**RFI 098
Pebble Project EIS**

Title/Subject:	TSF Options, Mine Area
Requestor:	AECOM
Date Transmitted:	10/16/2018
Recipient:	Pebble Limited Partnership (PLP)
Response Requested by:	10/22/2018
Rationale:	The PLP response for RFI 069 presented 26 potential TSF locations that were considered near the mine area. Details on feasibility and environmental considerations for these locations are necessary for alternatives screening purposes and for the USACE to evaluate the Least Environmentally Damaging Practicable Alternative (LEPDA).
Describe the Information Requested and Level of Detail:	<p>Please provide an evaluation of each mine area TSF location that was considered and explain why the NFK West and NFK East locations were ultimately selected. Include:</p> <ul style="list-style-type: none"> • Feasibility (technology, economics, logistics, common sense) • Availability (both now and ten years ago during project planning) • Environmental impacts (wetlands/Waters of the US, miles of streams, habitat, fill, dam safety, etc.)

The question presented in RFI 098 on TSF options in the mine area is addressed below:

TSF OPTION 1

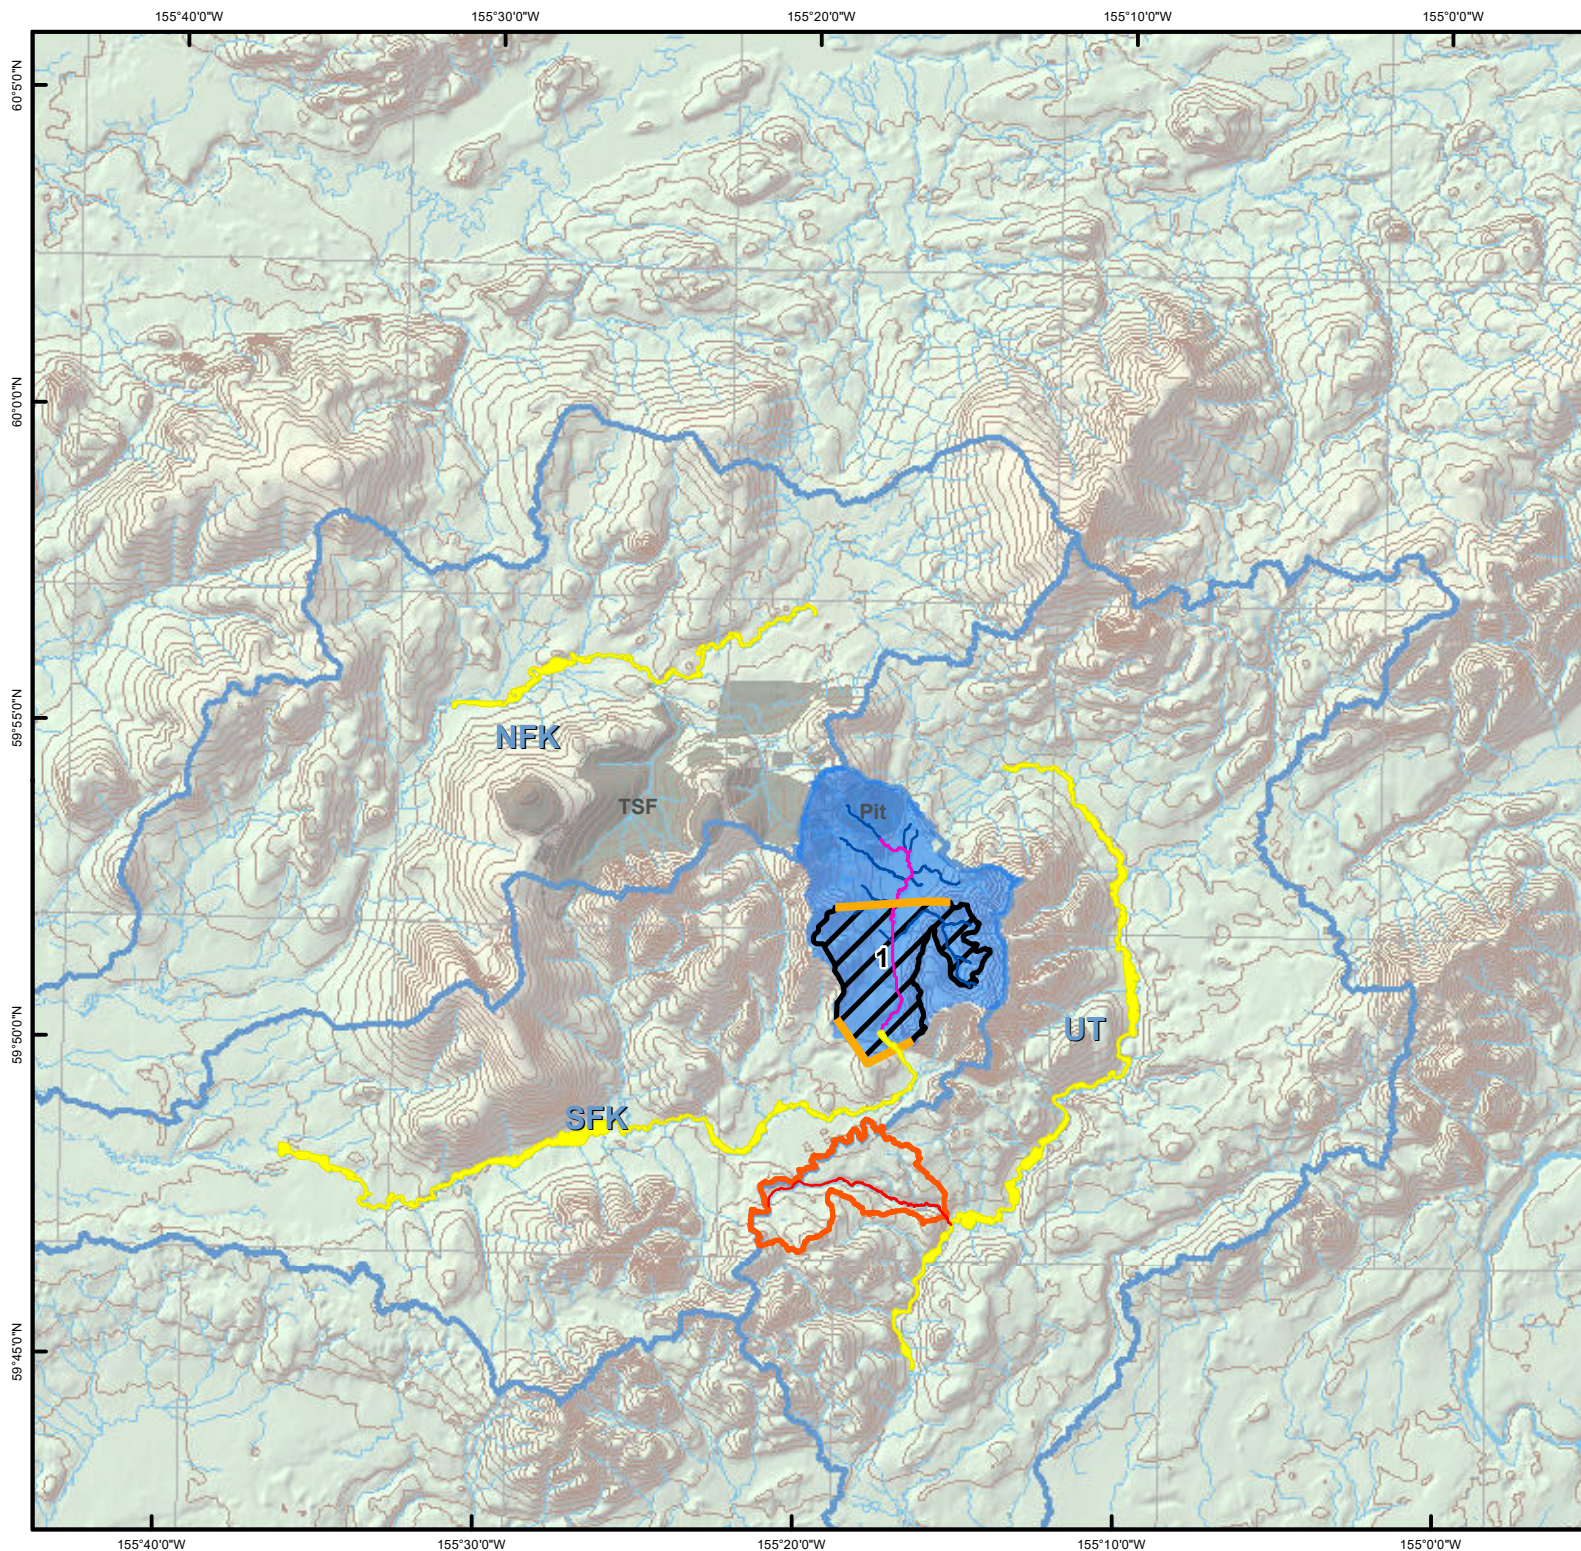
Option 1

- Has a similar impact footprint, but results in less filling of mapped wetlands.
- Fish-bearing and anadromous stream miles impacted are higher for this option and the impacted drainage basin is larger.
- Embankment location precludes effective collection of seepage from a flow-through embankment and would have the potential to impact groundwater flows into the SFK and UTC 119A drainages.
- The footprint encroaches on MCO393.

TSF OPTION 2

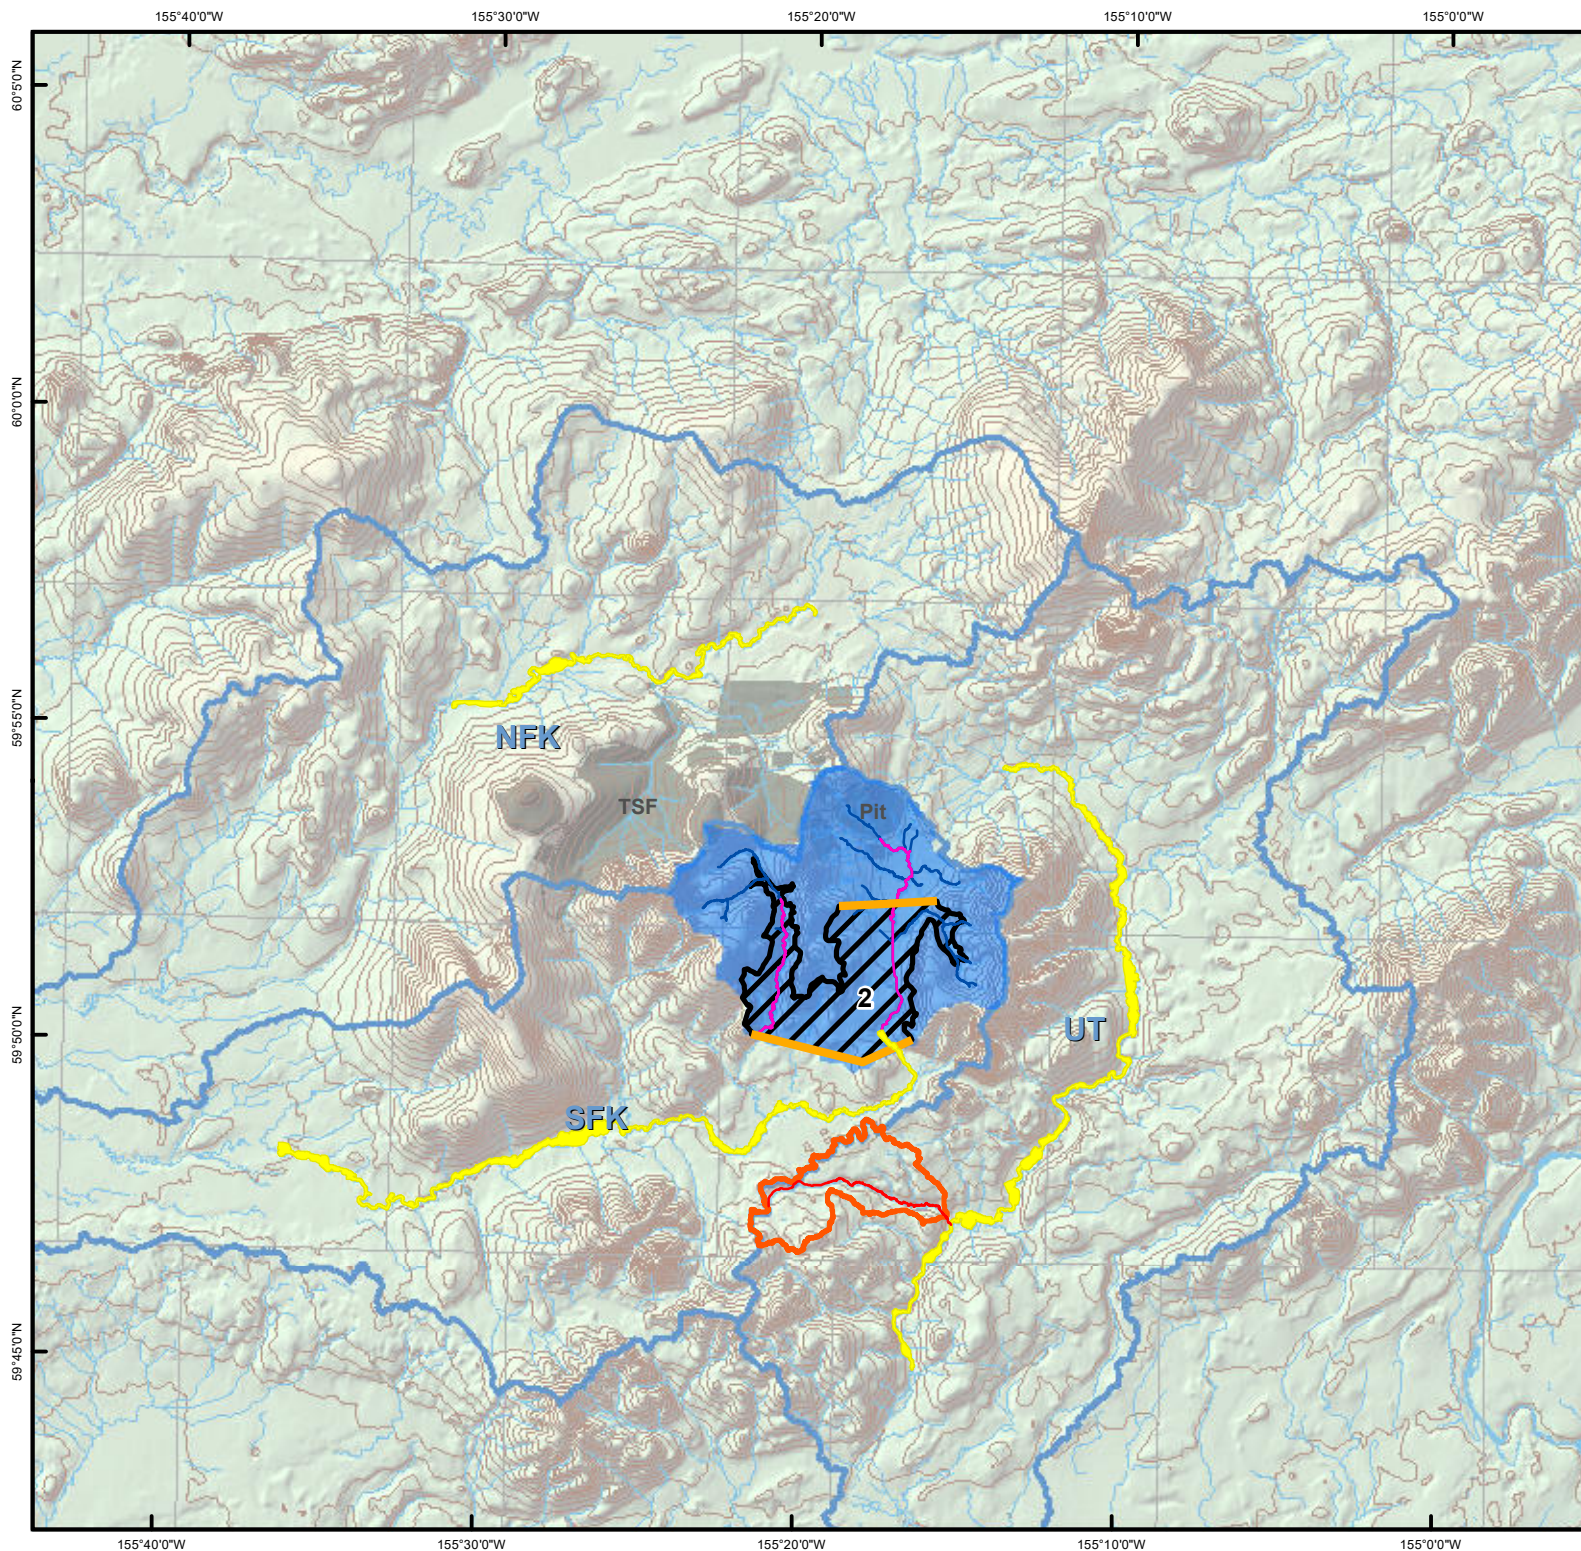
Option 2

- Has a larger impact footprint than the proposed project and fills more stream miles, but results in less filling of mapped wetlands.
- Impacted fish-bearing and anadromous stream miles, and the impacted drainage basin, are more than doubled for this option.
- Embankment location precludes effective collection of seepage from a flow-through embankment and would have the potential to impact groundwater flows into the SFK and UTC 119A drainages.
- The footprint encroaches on MCO393.

TSF OPTION 3

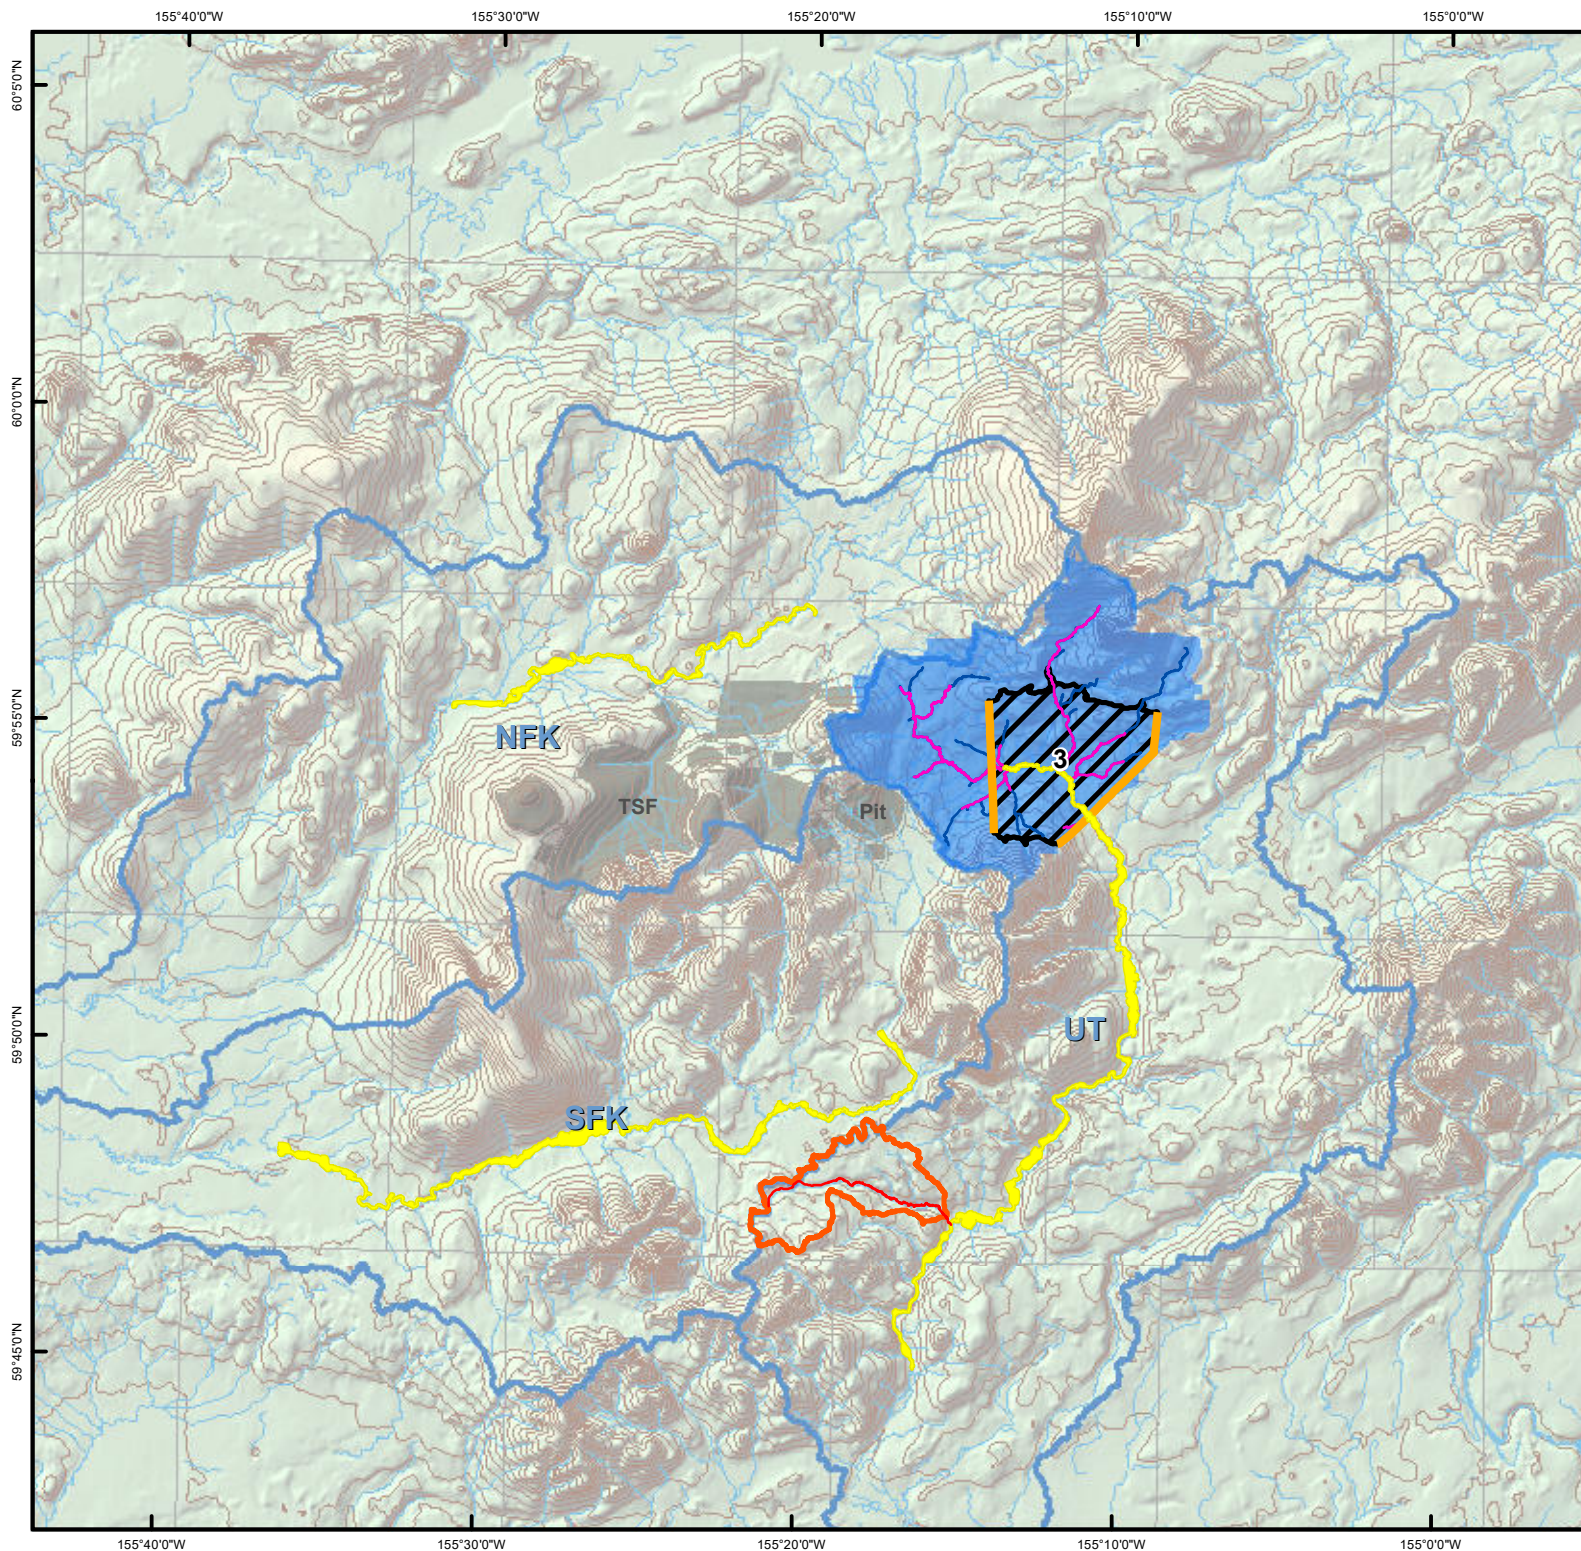
Option 3

- Extends direct impacts into the UTC drainage.
- Has a larger footprint and fills more wetland acres and stream miles than the proposed project.
- The impacted drainage basin is much larger and impacts to fish-bearing and anadromous streams are substantially higher.
- The footprint has extensive overlap with MCO393.

TSF OPTION 4

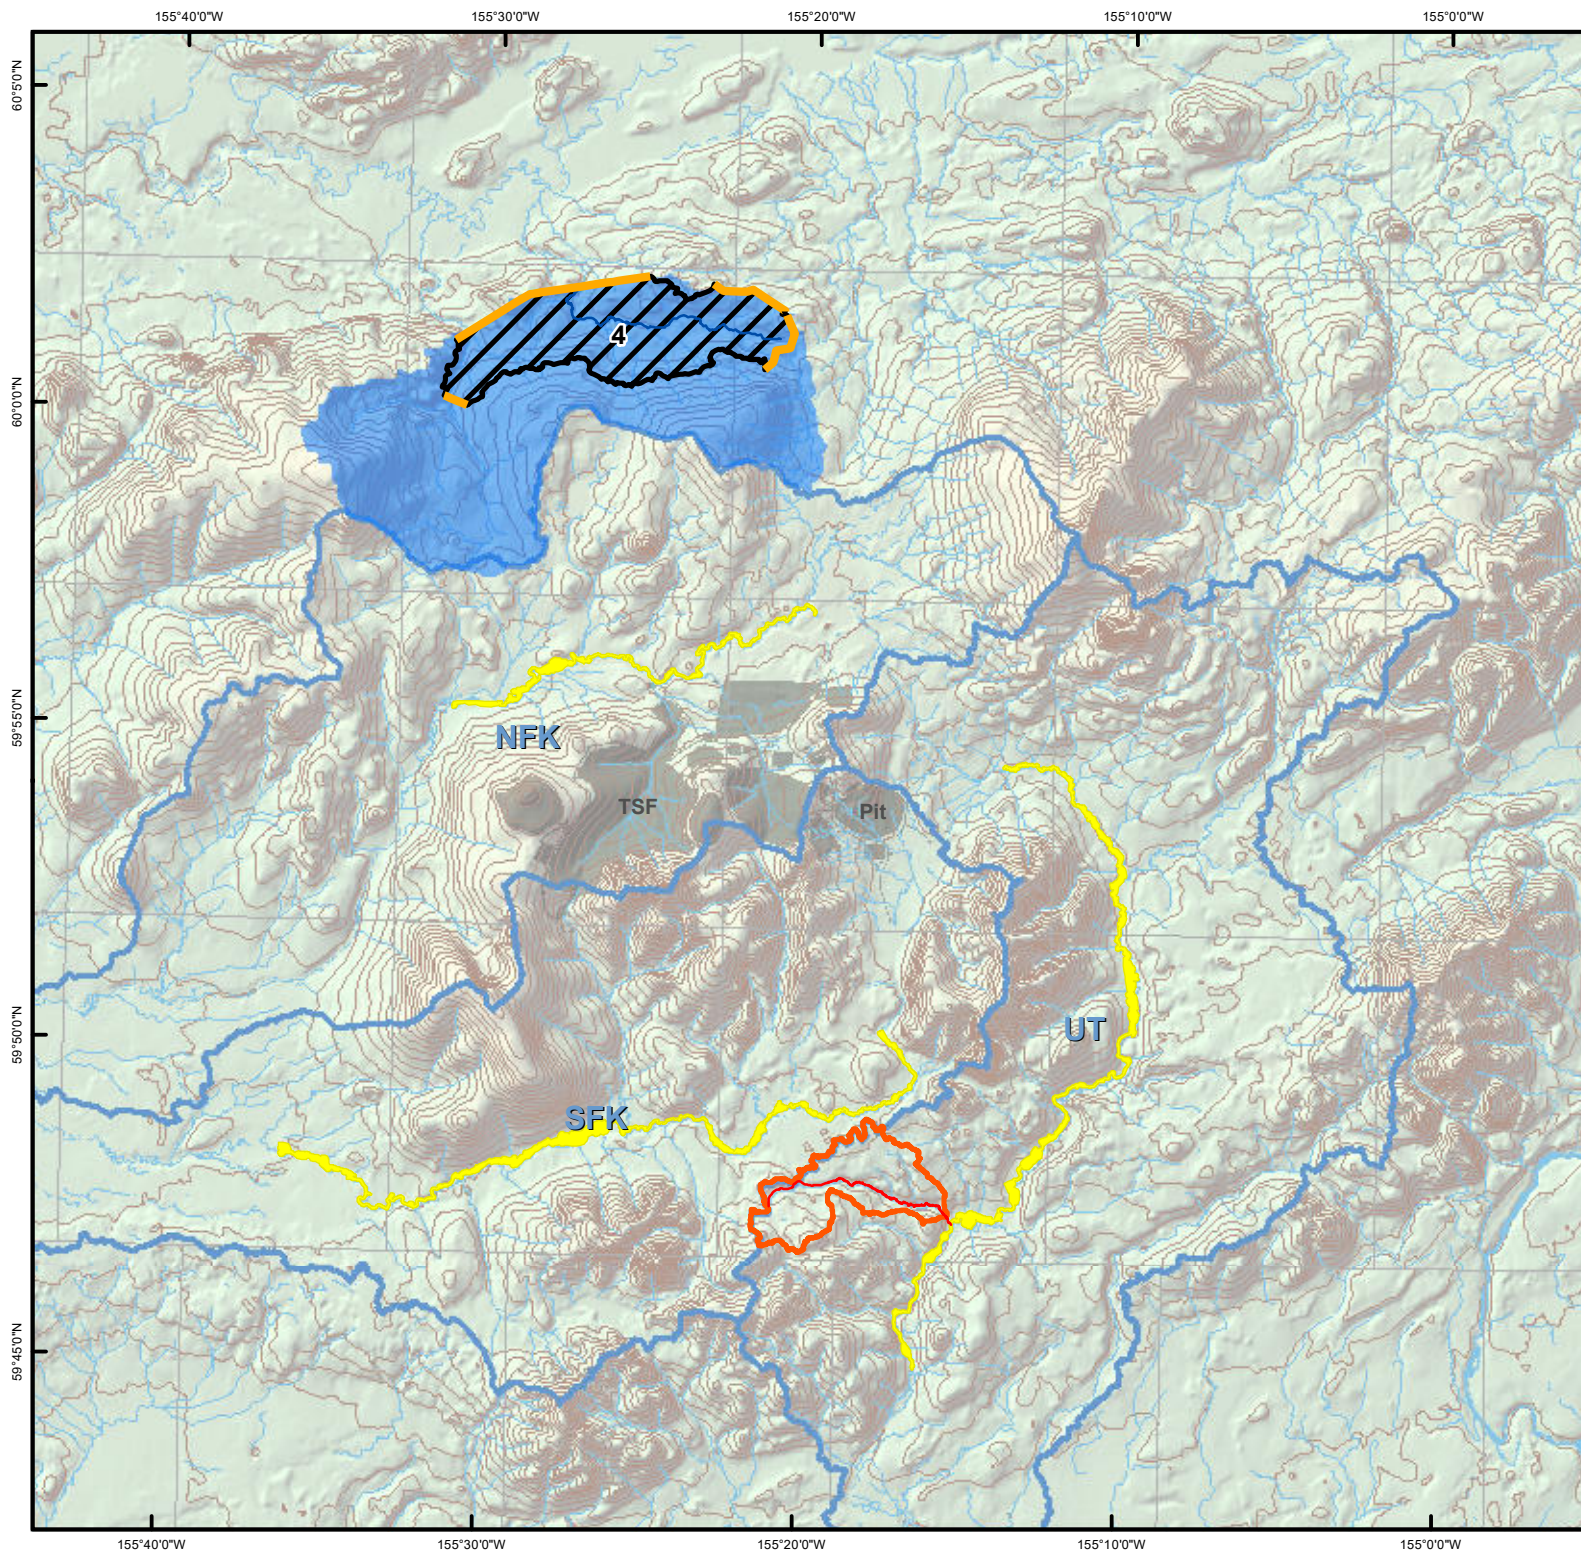
Option 4

- Extends direct impacts into the Lake Clarke drainage.
- Has a larger footprint.
- No PLP or NWI wetlands information for this option is available, so data from the Alaska Wetlands Map (AWM) was used to provide a rough estimate. The wetlands impacts are of a similar order of magnitude (2000 acres) to the proposed project. Stream miles filled are nearly doubled which also suggests that the AWM data may undercount actual wetlands in the area.
- The impacted drainage basin is about three times as large.
- Fish-bearing stream miles impacted are lower, although it should be noted that the level of study in this area is less.
- Tailings would need to be pumped for 17 miles, resulting in significantly higher energy consumption and the overall project footprint would be significantly larger and more dispersed with this option.
